ADDENDUM 01

July 24, 2026

Bradford Exempted Village Schools
New Athletic Facility
760 Railroad Avenue
Bradford, OH 45308

LPA PROJECT NO. 263401.00

26 REFLECTED CEILING PLAN

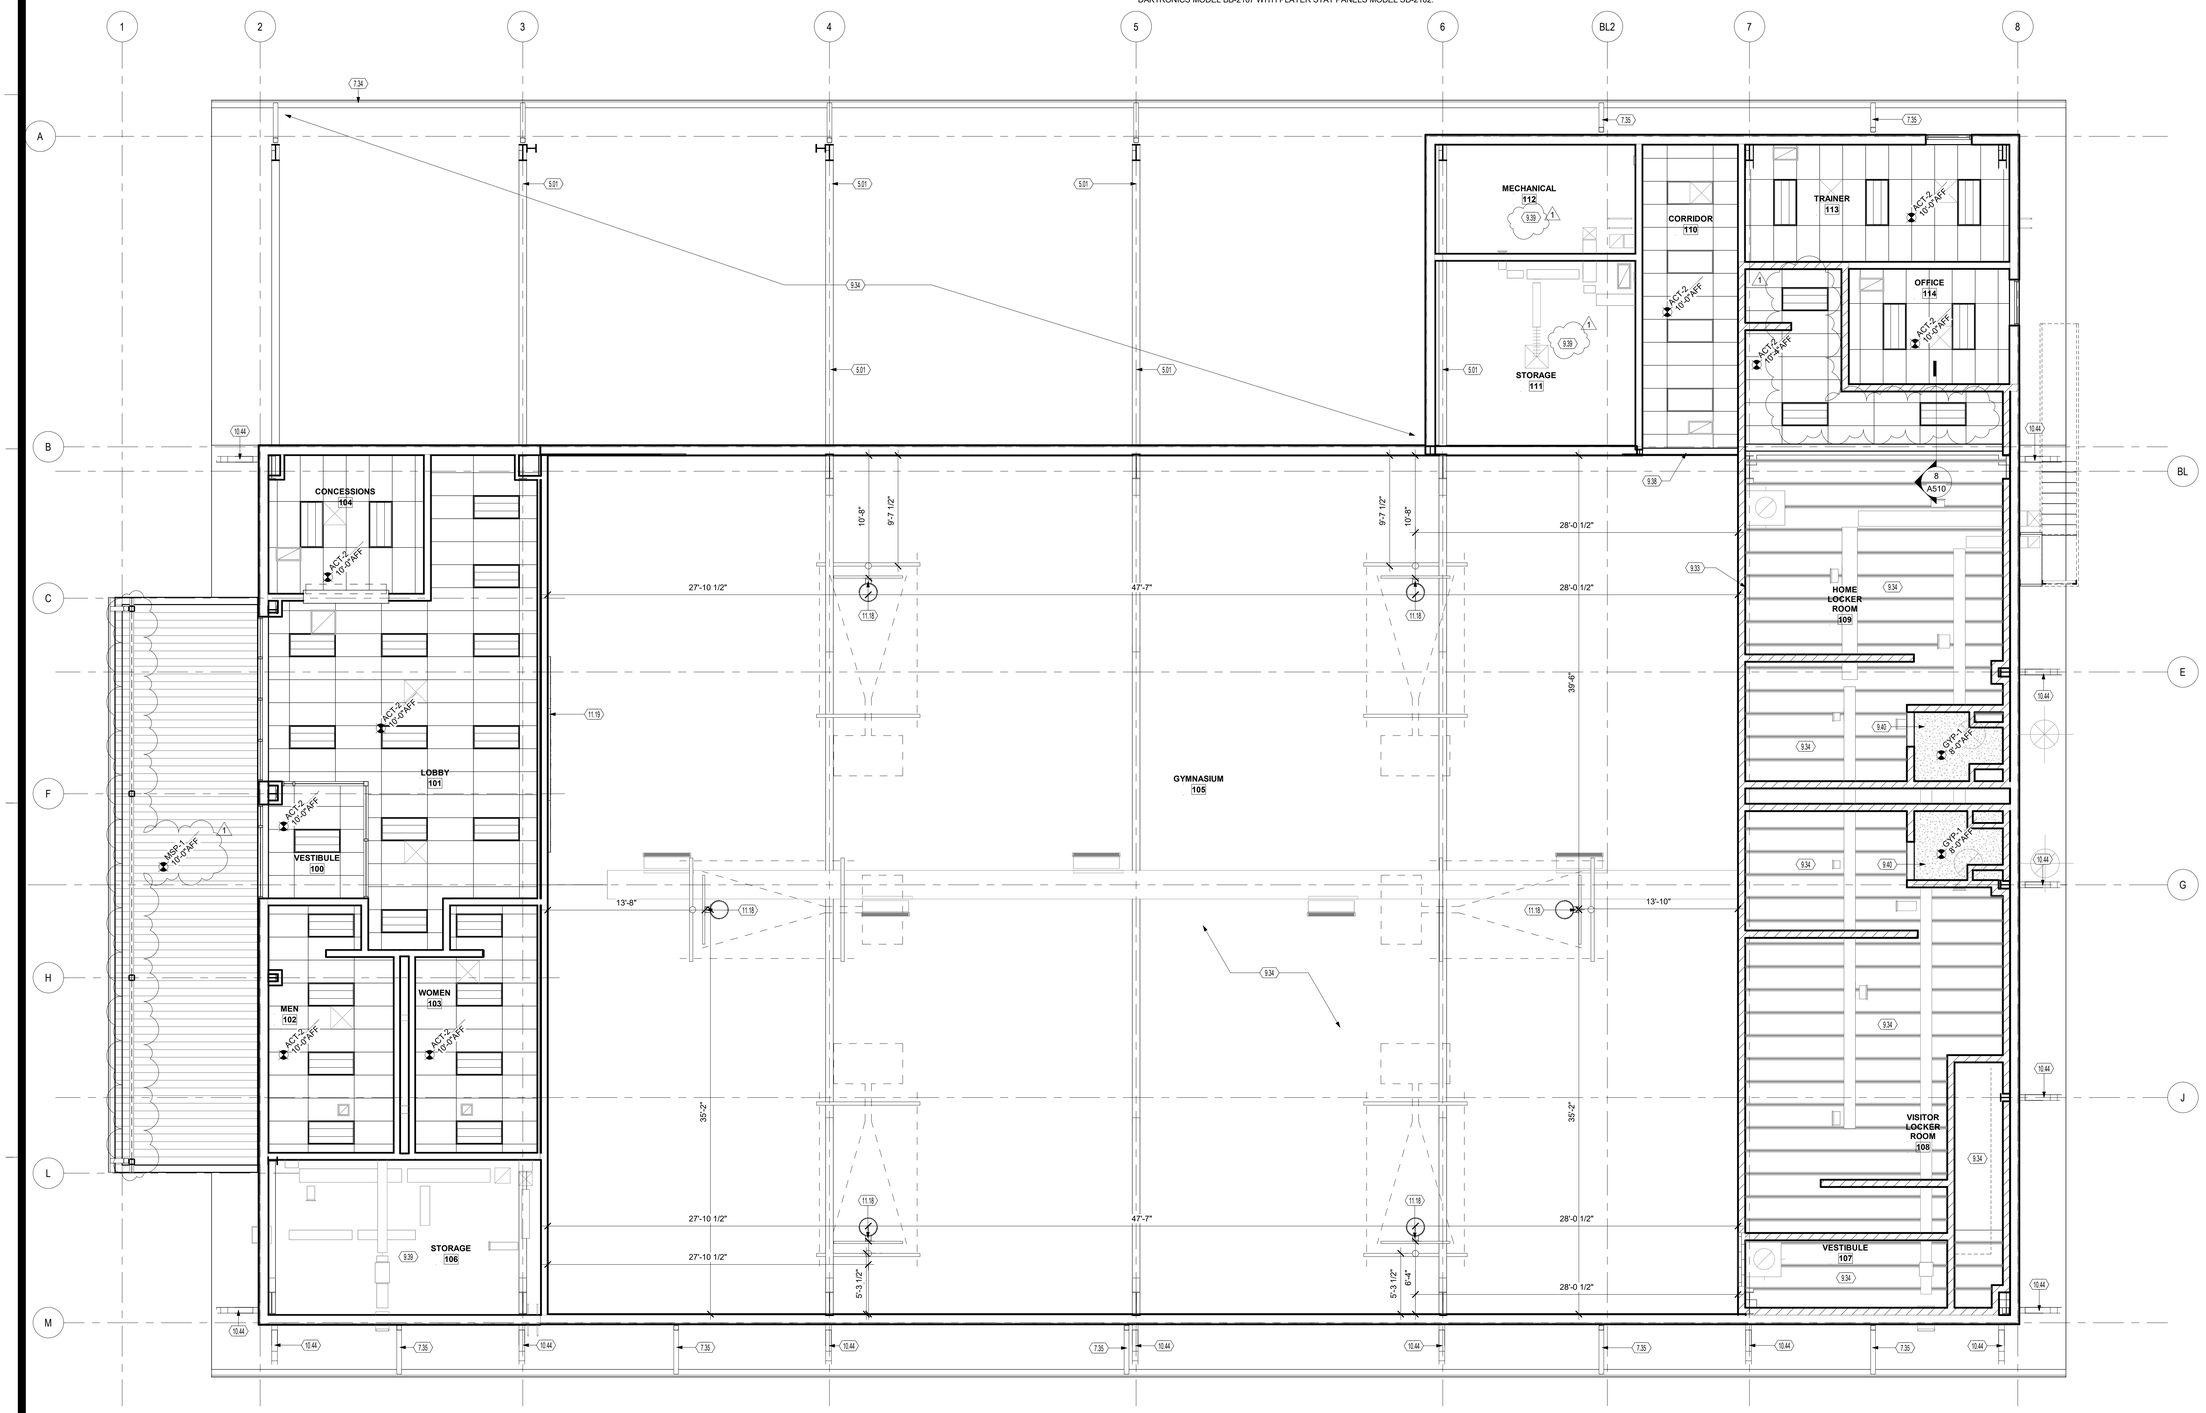
1.6 Question: On sheet A121, what is the ceiling on the front entrance canopy?

2.5 Sheet A121 – REFLECTED CEILING PLAN.

2.5.3 Revised lighting layout in the Home Locker Room 109 at the ACT ceiling to match the electrical drawings.

1.6.1 Response: The ceiling for the front entrance canopy is a metal panel soffit similar to Berridge L-Panel with an embossed stucco texture and vee grooves. This will be installed on 6” metal studs at 24” on center with 1-1/2” hat channel furring at 24” on center. See attached detail 26 on sheet A503 for the section / detail.

26 FIRST FLOOR FINISH PLAN
SCALE | 1/8" = 1'-0"

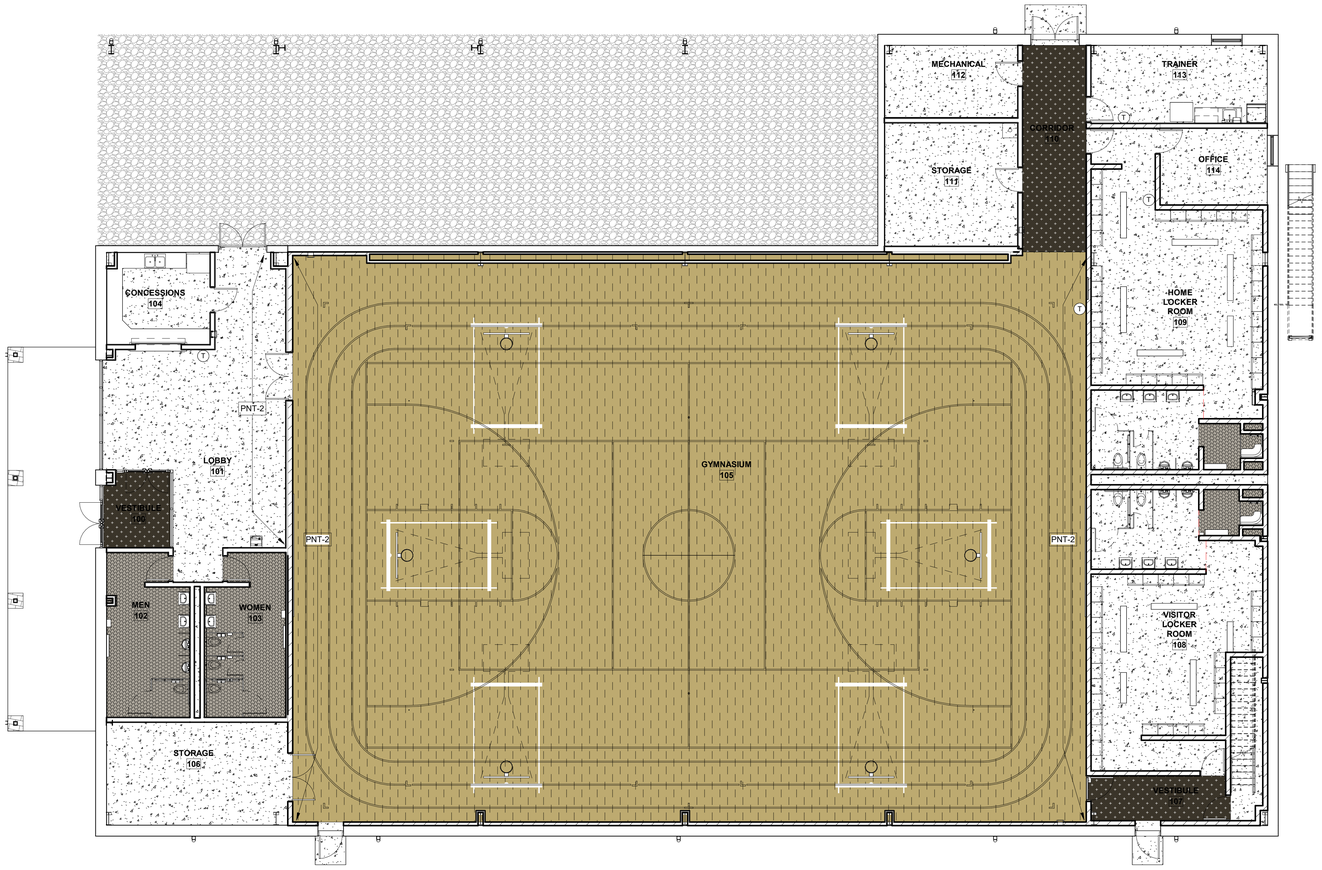
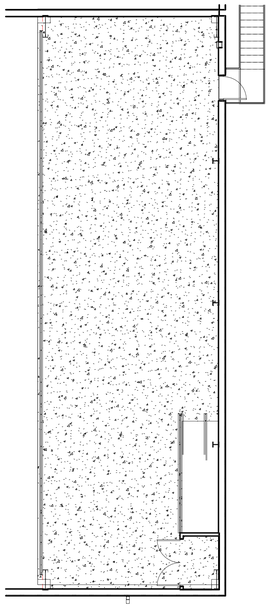
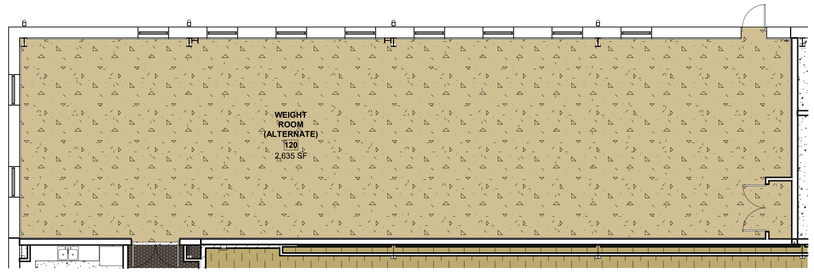
2.6 Sheet A131 – FINISH PLANS.

2.6.1 Added EXP-2 to the finish schedule. This is for rooms without ceilings and exposed structure. The exposed structure and other ceiling items in rooms with this ceiling designation do not need to be painted.

2.6.2 Added the EXP-2 ceiling designation to storage rooms 106, 111 and mechanical room 112.

26 ROOF PLAN
SCALE | 1/8" = 1'-0"

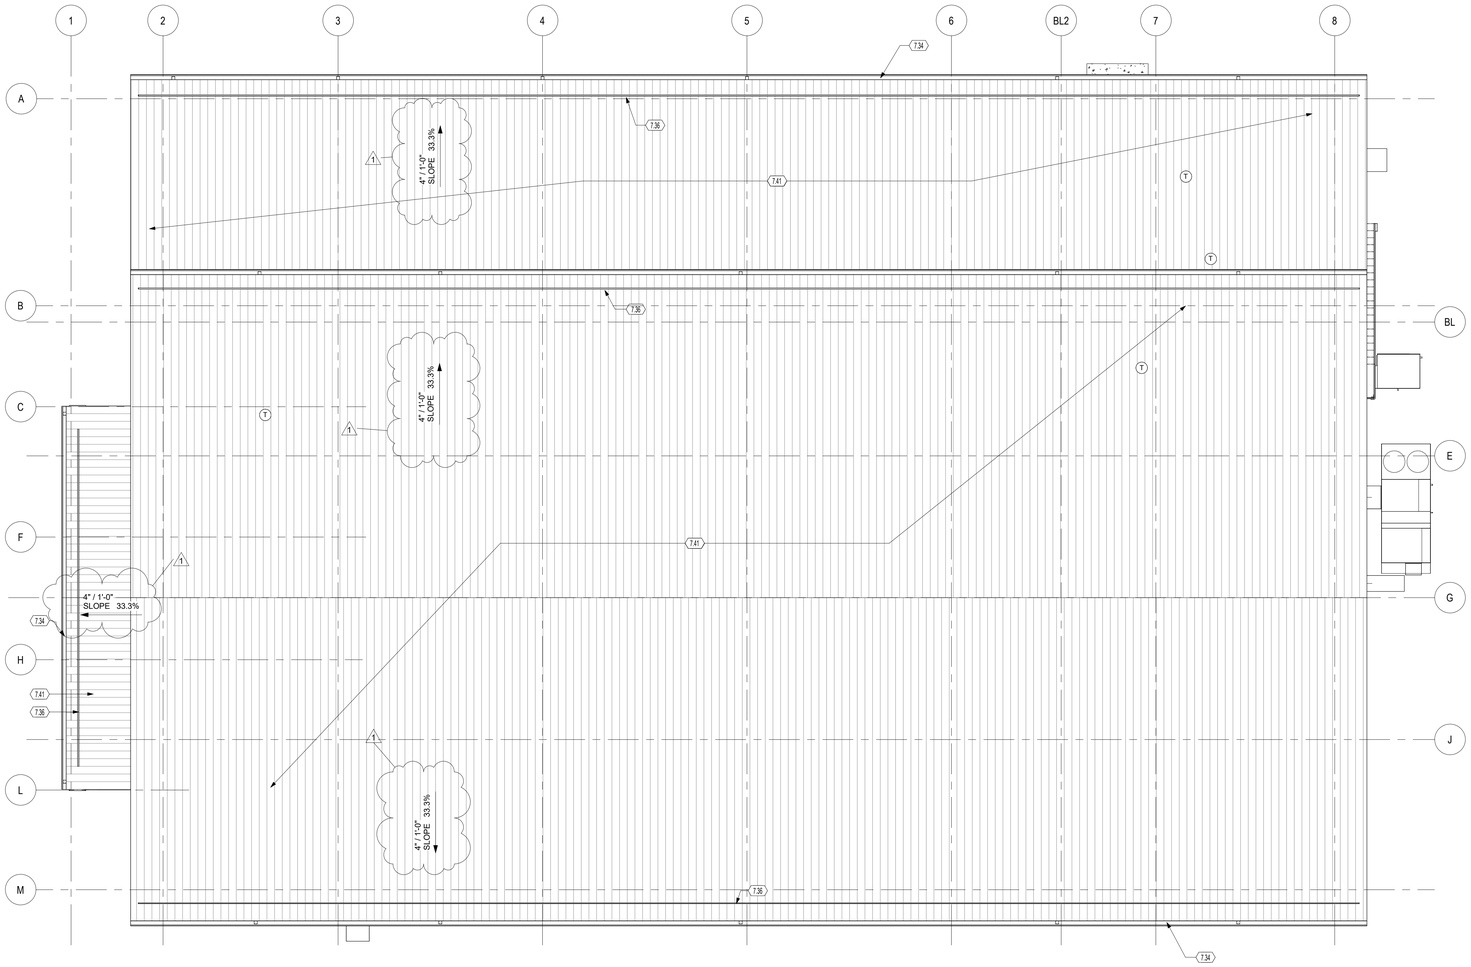
2.7 Sheet A141 – ROOF PLAN.

2.7.1 Added roof slopes to the roof plan.

26 EAST EXTERIOR ELEVATION

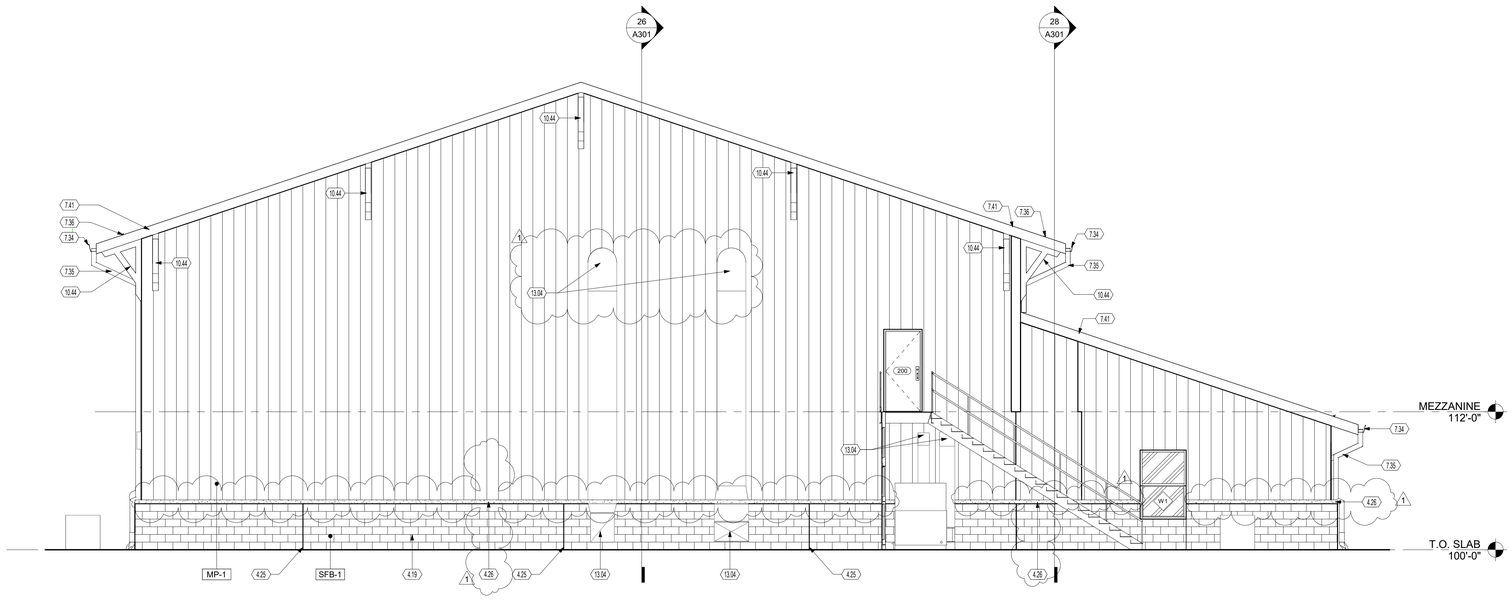
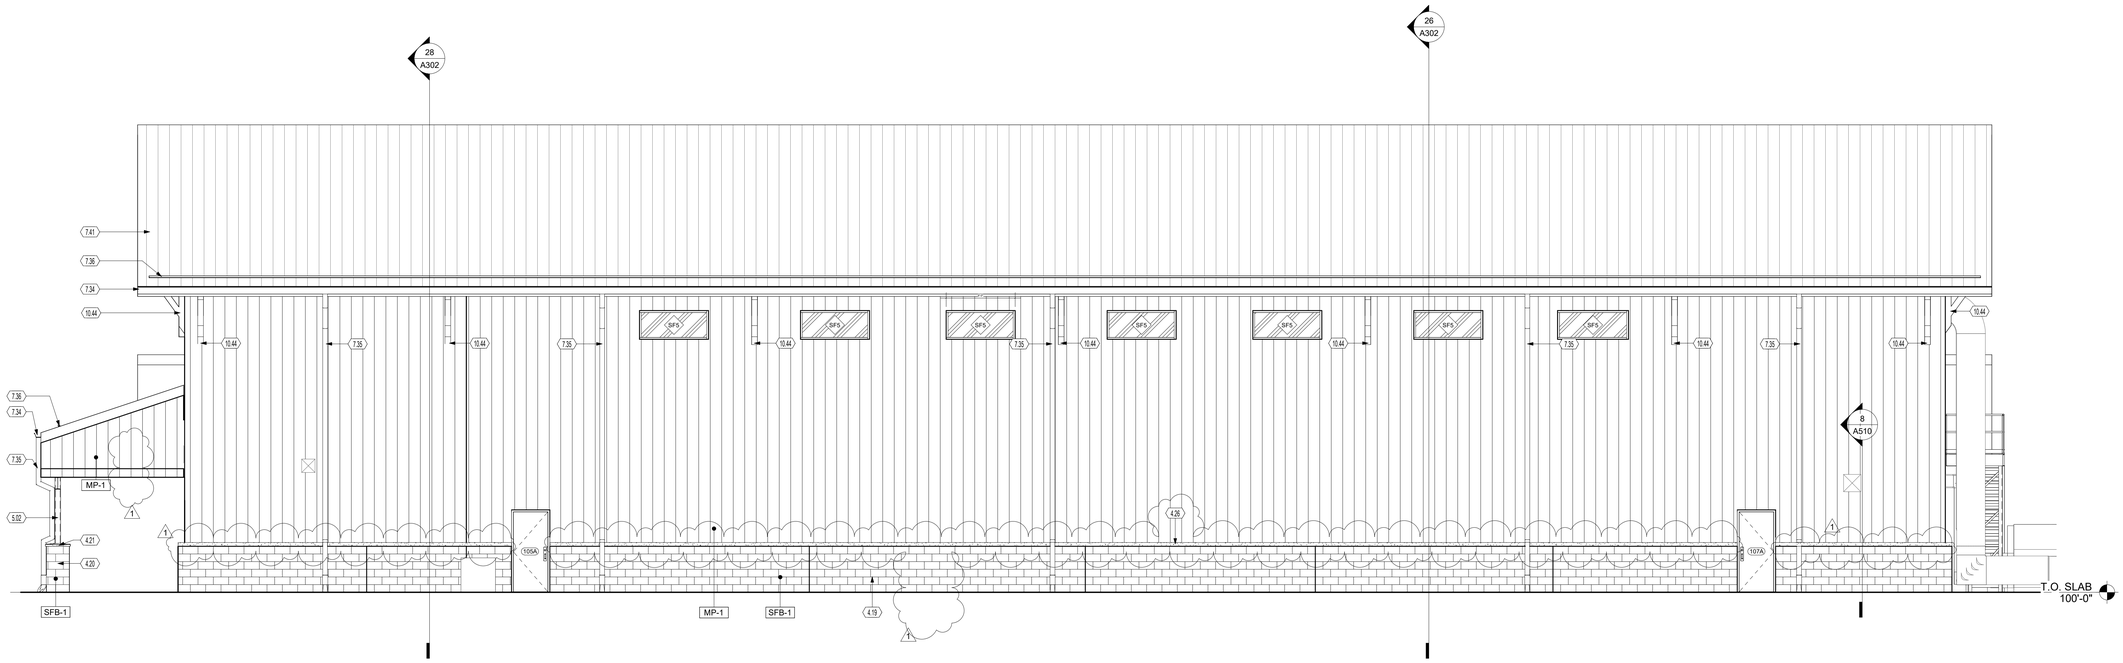
2.8 Sheet A201 – EXTERIOR ELEVATIONS.

2.8.1 Revised elevations to clarify ductwork arrangement.

2.8.2 Added alternate limestone water table at the CMU wainscot.

2.8.3 Deleted keynotes for the metal panel siding and added material designations for clarity.

26 WEST EXTERIOR ELEVATION

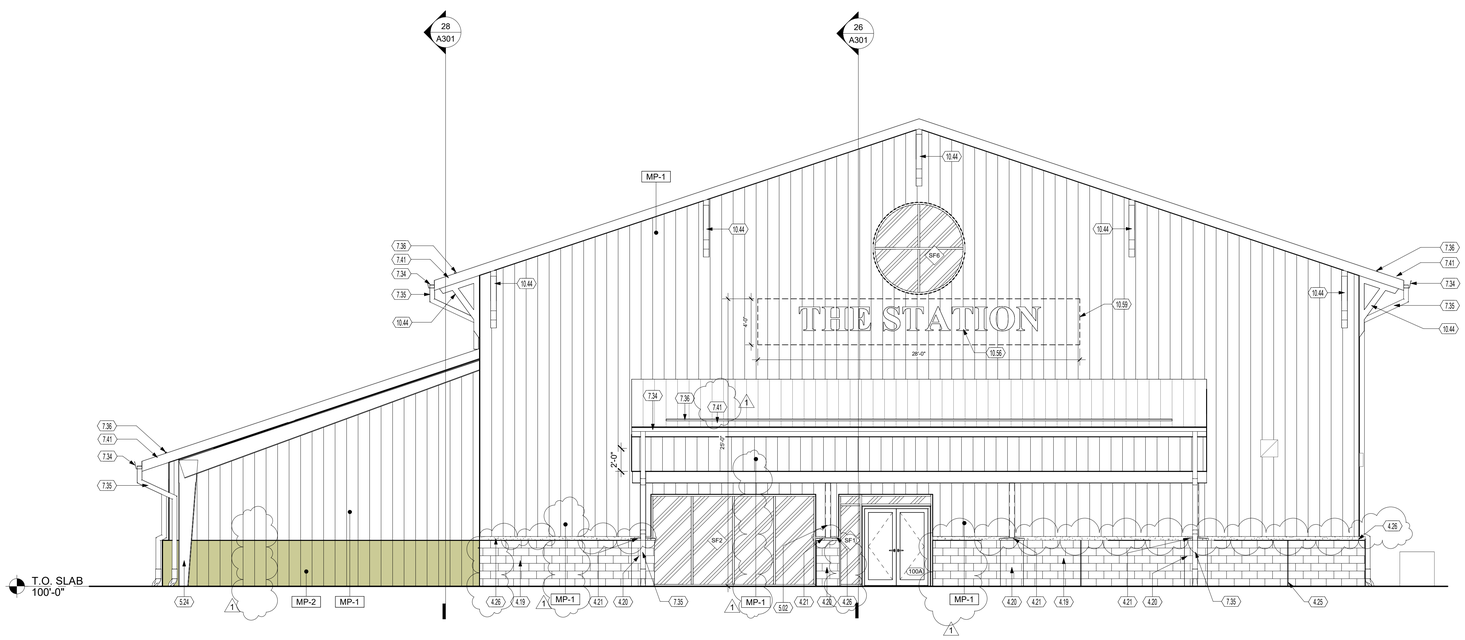
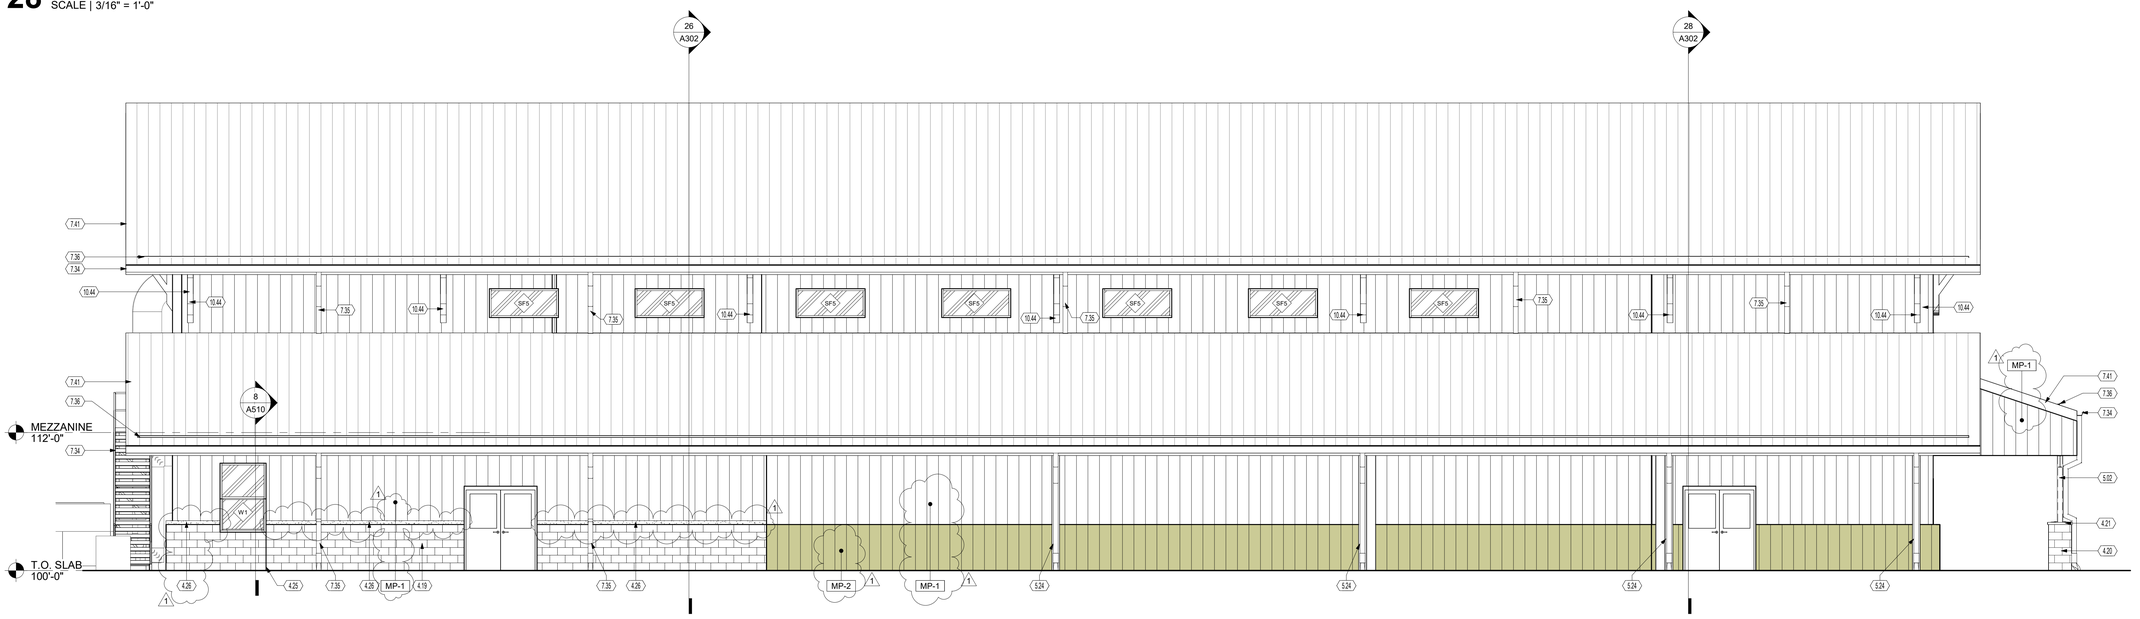
2.9 Sheet A202 – EXTERIOR ELEVATIONS.

2.9.1 Added alternate limestone water table at the CMU wainscot.

2.9.2 Deleted keynotes for the metal panel siding and added material designations for clarity.
